**Washington State
Department of Transportation**
Paula J. Hammond, P.E.
Secretary of Transportation

February 3, 2012

RE: *2012 Draft Stormwater Management Manual for Western Washington* Comments

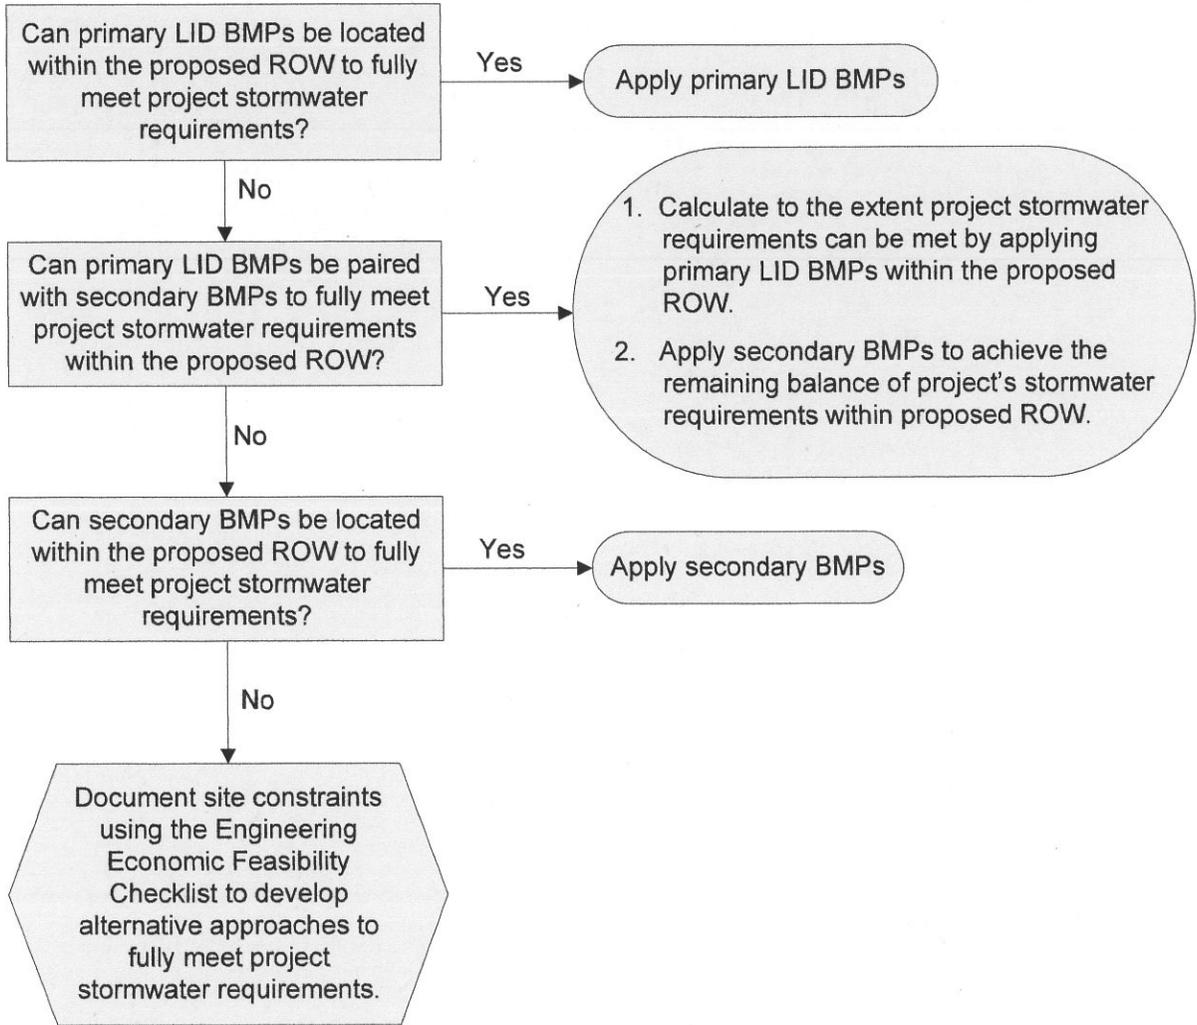
WSDOT's HRM currently directs designers to use the HRM's LID approaches (i.e., dispersion, bioinfiltration pond/swale, bioretention soils, compost amended vegetative filter strips, media filter drain, and infiltration pond/trench) to meet project stormwater requirements. In situations where LID approaches can only partially meet project stormwater requirements, the process depicted in the flowchart below would guide designers to incorporate LID approaches to the maximize extent feasible.

The figure below represents an idea of how such a LID process could work.

Primary BMPs = Dispersion, bioinfiltration pond/swale, bioretention soils, compost-amended vegetative filter strips, media filter drain, and infiltration pond/trench.

Secondary BMPs = All the remaining HRM “non-primary BMPs.
